Third Addendum to the Los Angeles Memorial Coliseum Renovation Project EIR

Existing and Proposed Video Board Graphics

**Los Angeles Memorial Coliseum
Potential Impacts of Approved vs. Modified
Project on Character-Defining Features
Review of Additional Modifications
Third Addendum, November 23, 2016**

Previously Approved Video Board Graphics

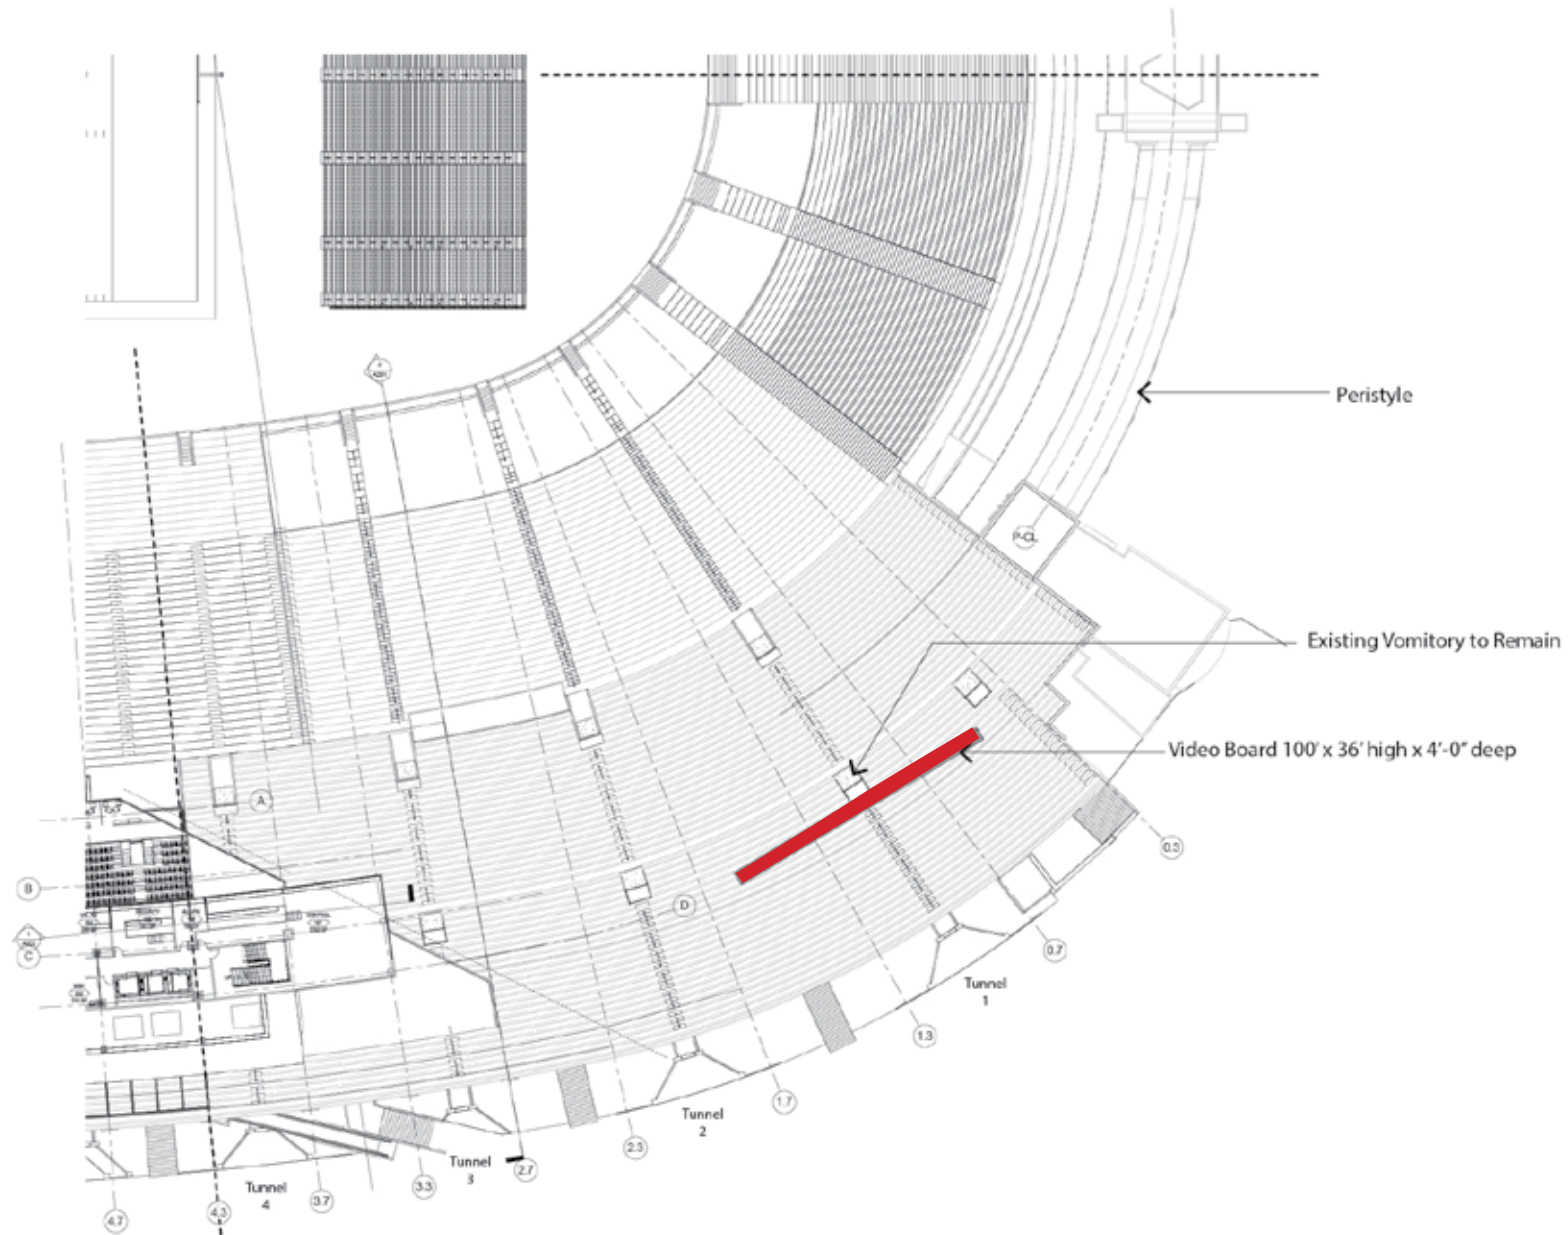
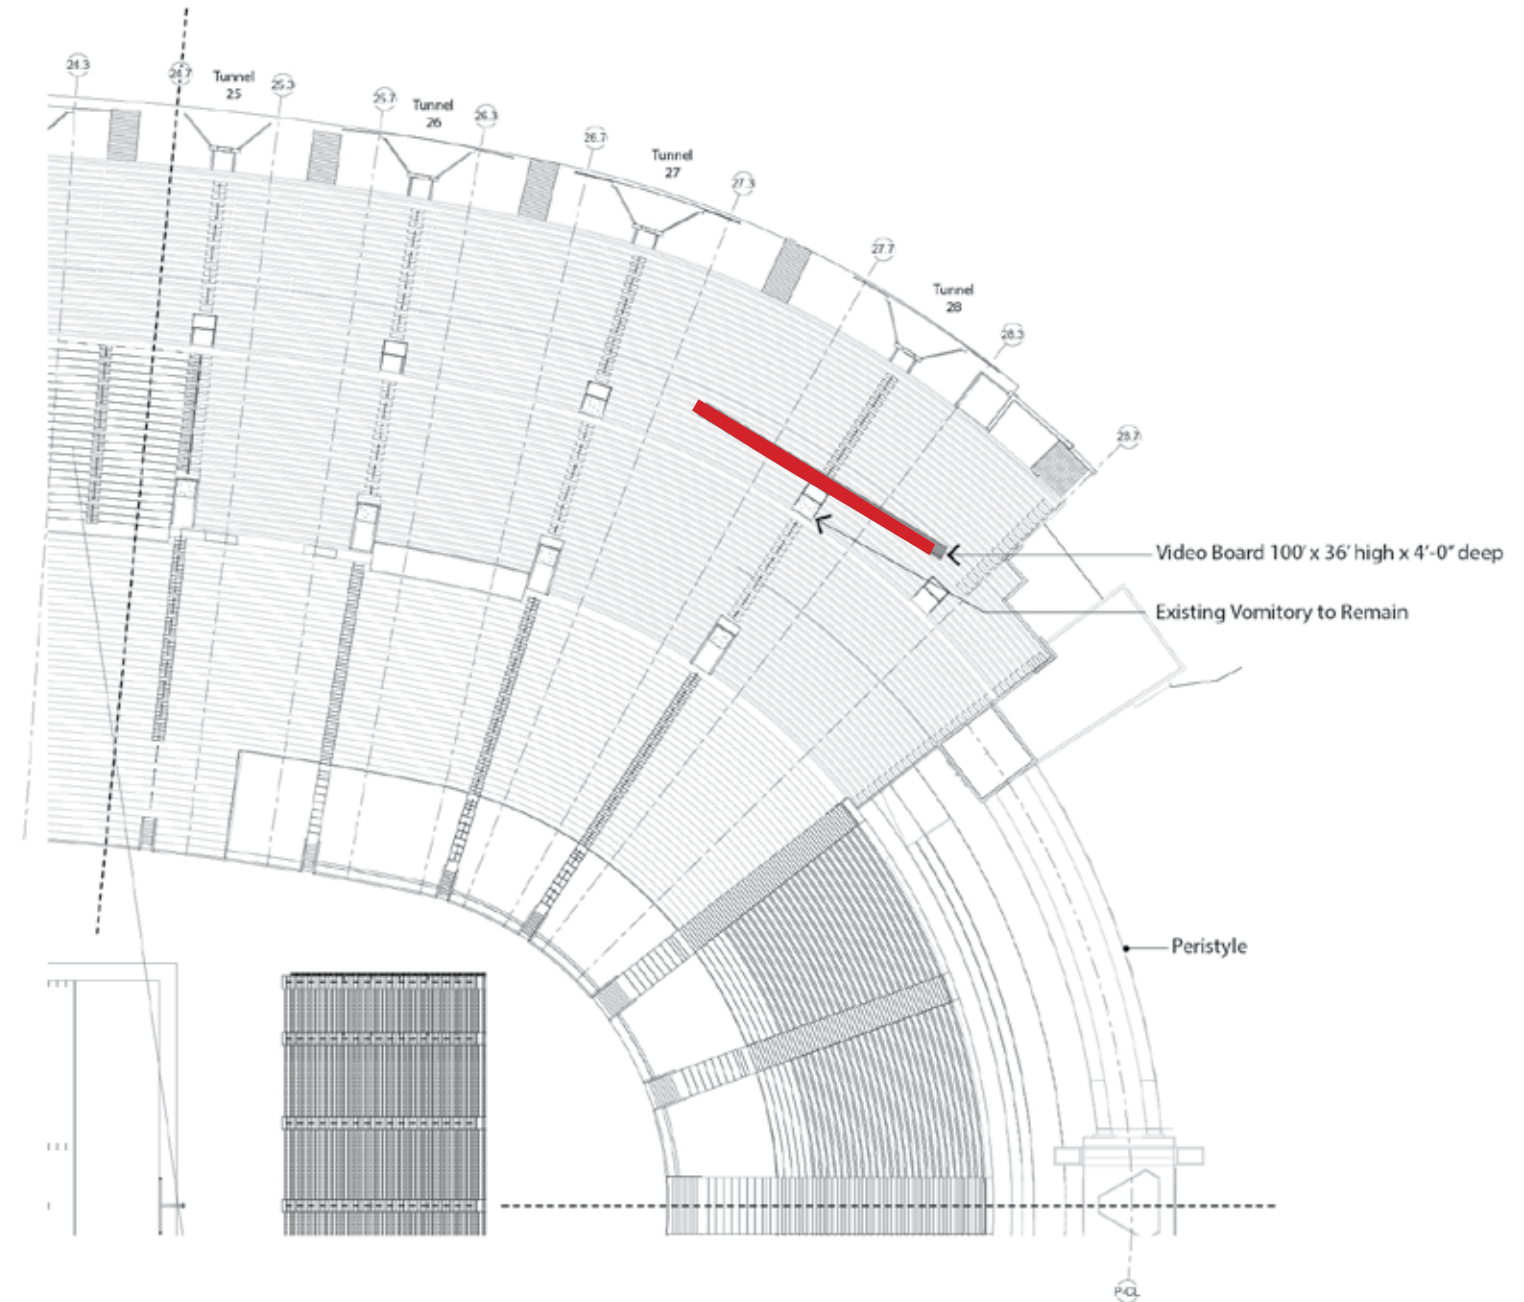
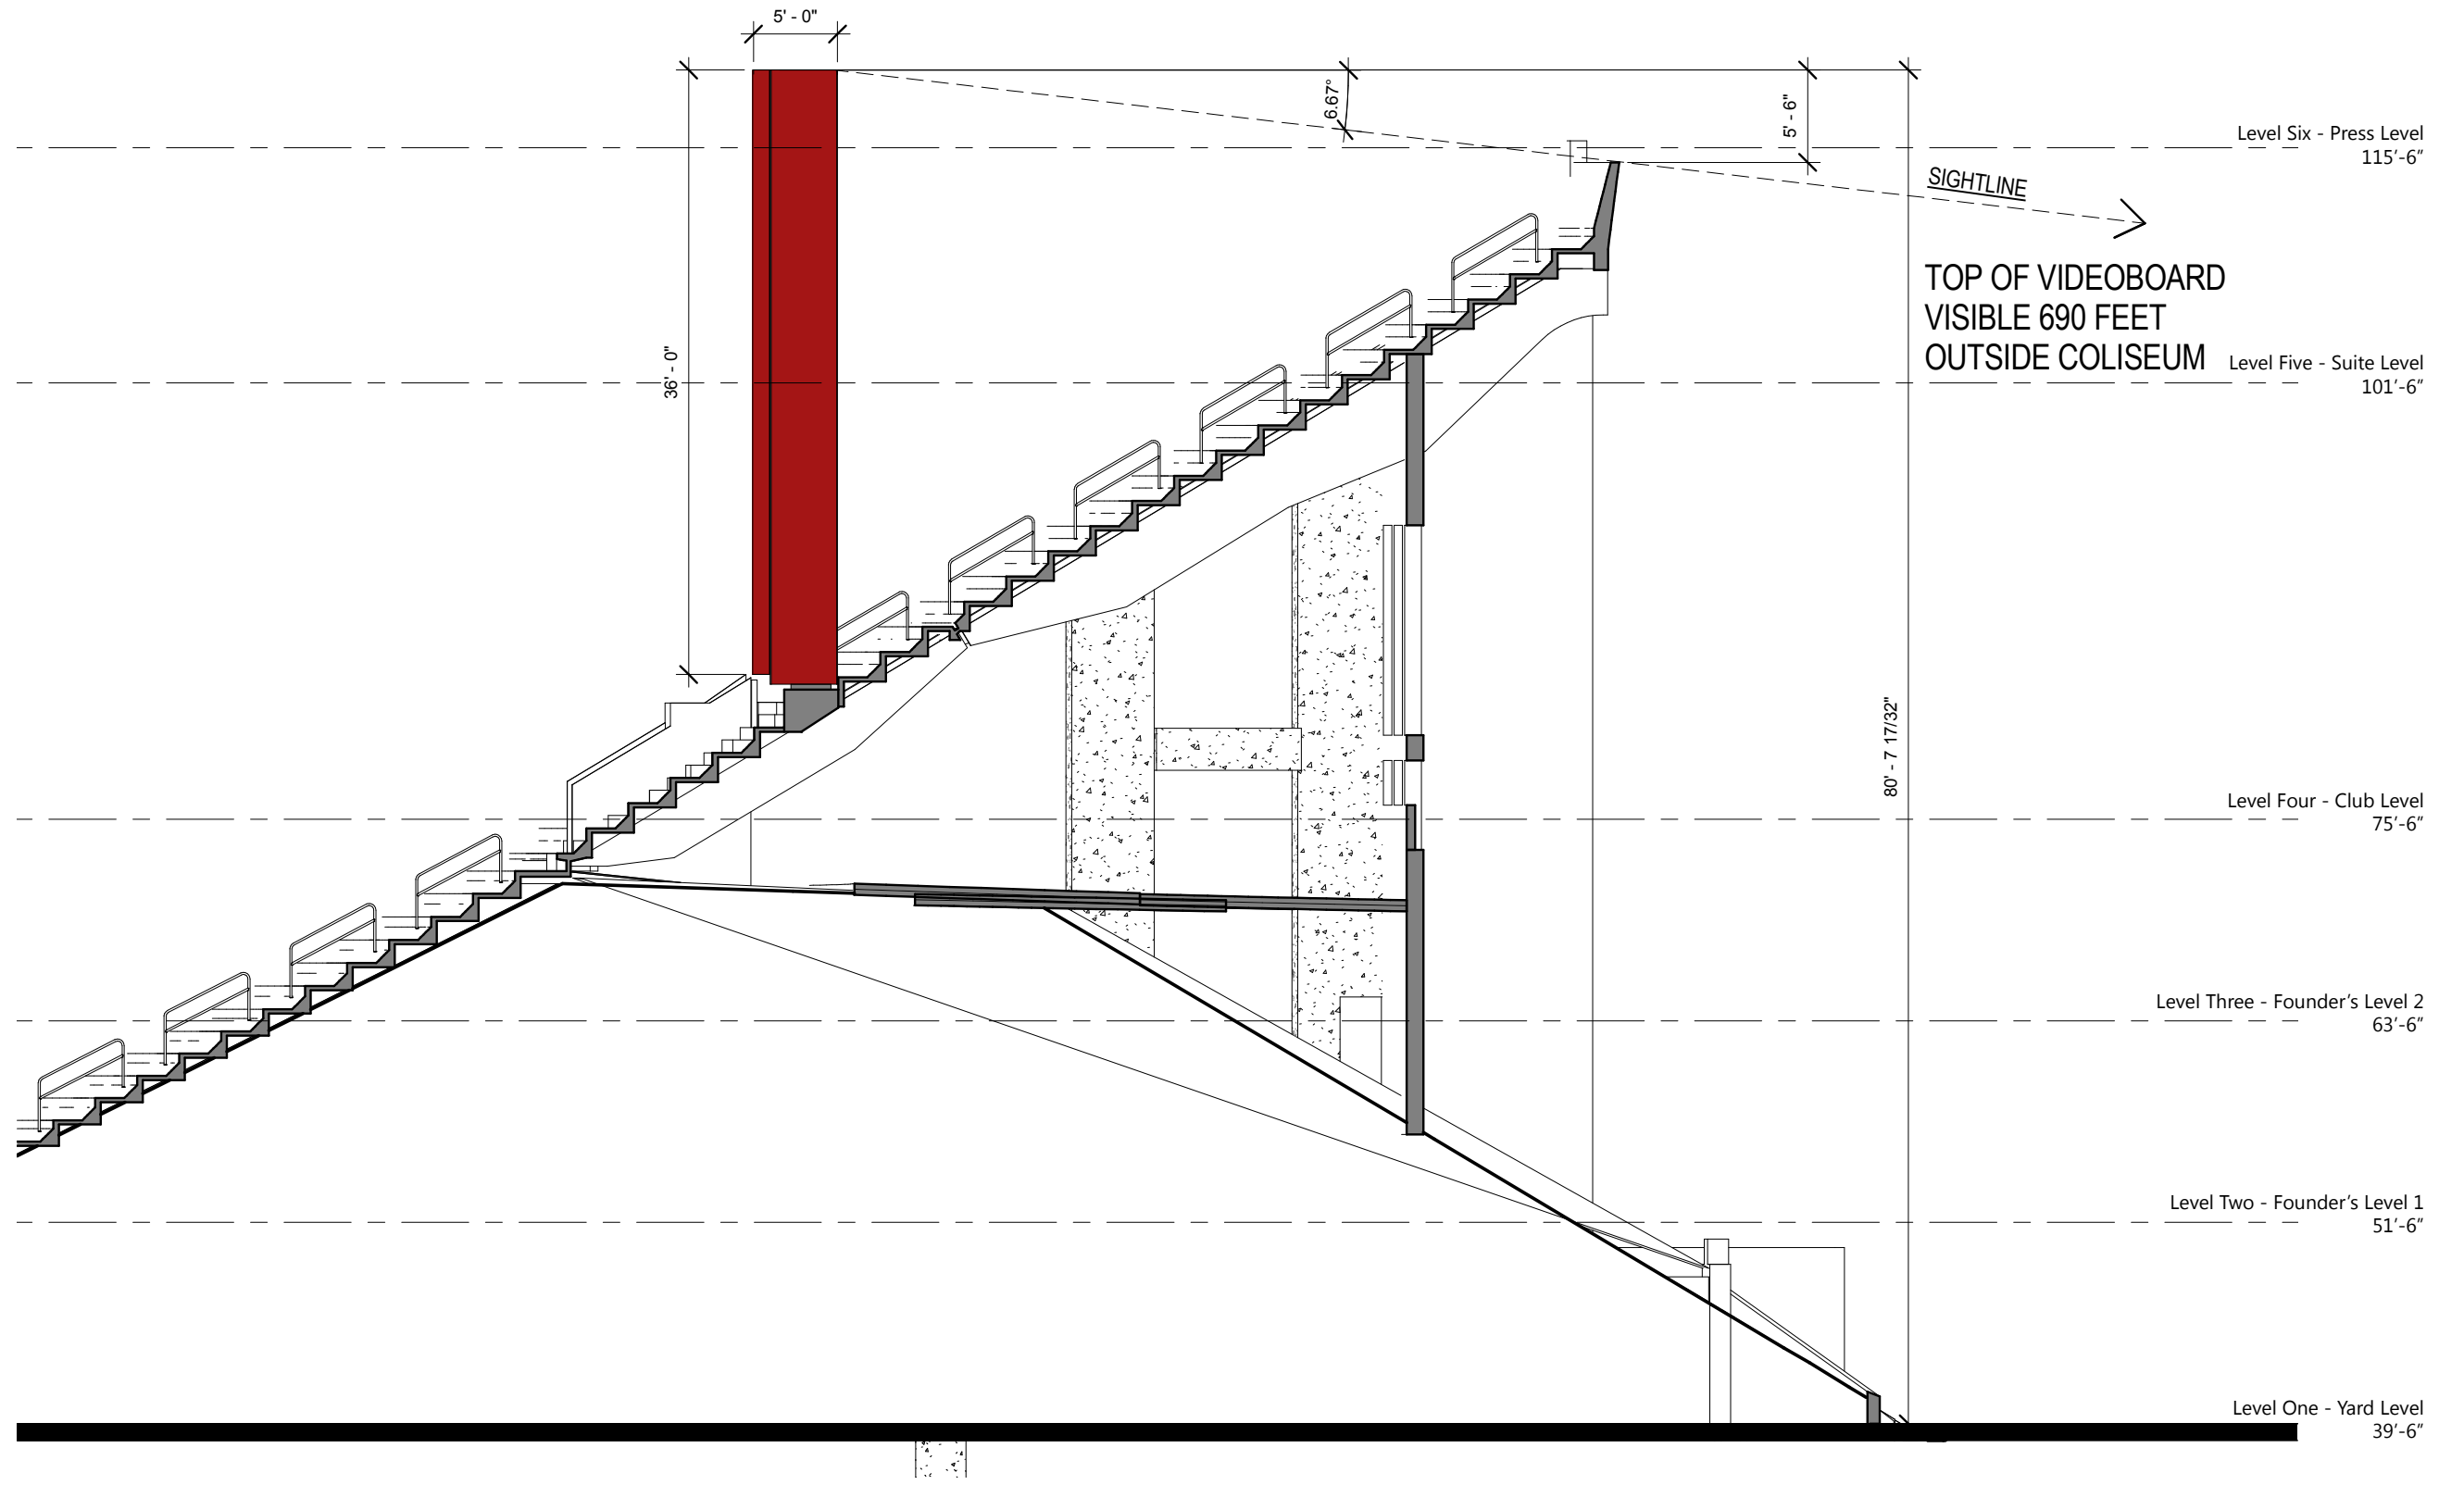
South Tower, View looking Southeast
Seats have been added in the areas adjacent to the addition.

Proposed Bowl Showing Added Aisles and 33" Seating Tread
